RADIANT HEATING SYSTEMS ACTUATOR CONVERSION

INSTRUCTION SHEET

Figure 1: Wiring a Two-wire Actuator to a New Uponor Zone Control Module (A3031003, A3031004)

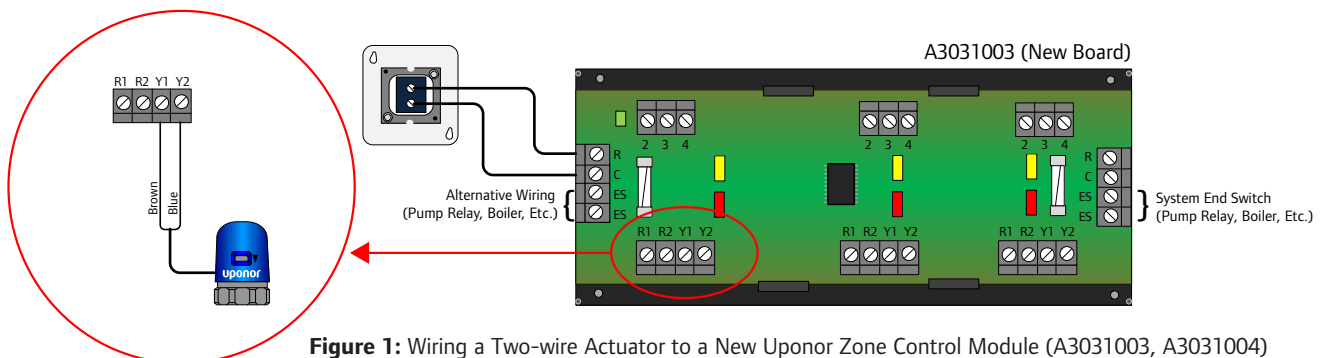
Replacing with a Two-wire Thermal Actuator

Uponor Two-wire Thermal Actuators (A3030522, A3030523, A3020416) typically require three (3) minutes to open versus 10 seconds for an

MVA. However, given the dynamics of a radiant system, the delay will be unnoticeable to end users. And because there are fewer connections, the Two-wire Thermal Actuators also greatly reduce wiring time and complexity.

Important! Two-wire Thermal Actuators are only compatible with the new Uponor Zone Control Modules (A3031003, A3031004).

1. Remove the MVA and install the new Two-wire Thermal Actuator.

2. Remove power from the old Uponor Zone Control Module (ZCM) (A3030003, A3030004) and replace with a new ZCM (A3031003, A3031004).
3. Terminate brown and blue actuator motor wires to the Y1 and Y2 terminals.
4. Terminate the system end switch to the ES terminals on the new ZCM.
5. Connect 24-volt power to the new ZCM.

Figure 2: Wiring a Four-wire Actuator to an Old or New Uponor Zone Control Module (A3030003, A3030004, A3031003 or A3031004)

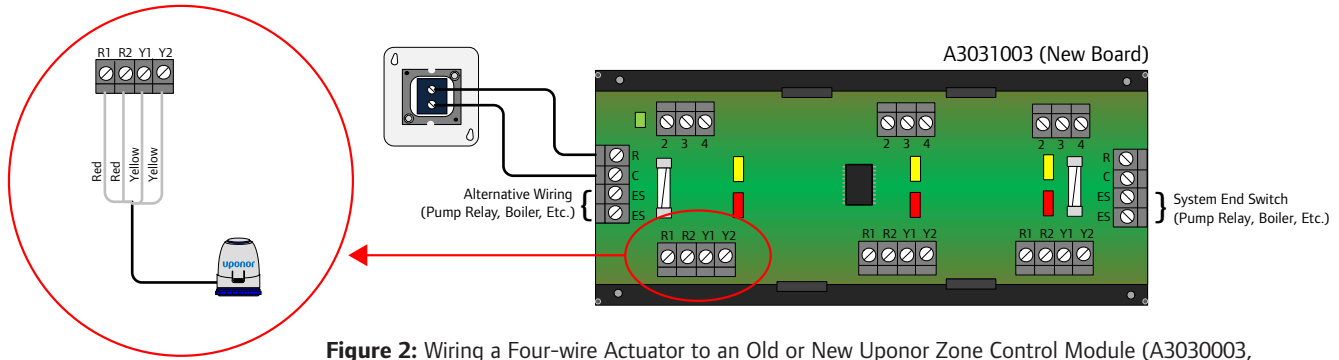
Replacing with a Four-wire Thermal Actuator

Uponor Four-wire Thermal Actuators (A3010522) typically require three (3) minutes to open versus 10 seconds for an MVA. However, given the dynamics of a radiant system, the delay will be unnoticeable to end users. Four-wire Thermal Actuators also provide greater reliability while greatly reducing wiring time and complexity. Note that the Four-wire Thermal Actuator

is compatible with both the old (A3030003, A3030004) and new (A3031003, A3031004) ZCMs.

1. Remove the MVA and install the new Four-wire Thermal Actuator.
2. Remove power from the Uponor Zone Control Module (ZCM) (A3030003, A3030004, A3031003 or A3031004)

3. Terminate red end switch wires to the R1 and R2 terminals.
4. Terminate yellow actuator motor wires to the Y1 and Y2 terminals.
5. Terminate the system end switch to the ZCM.
6. Connect 24-volt power to the ZCM.
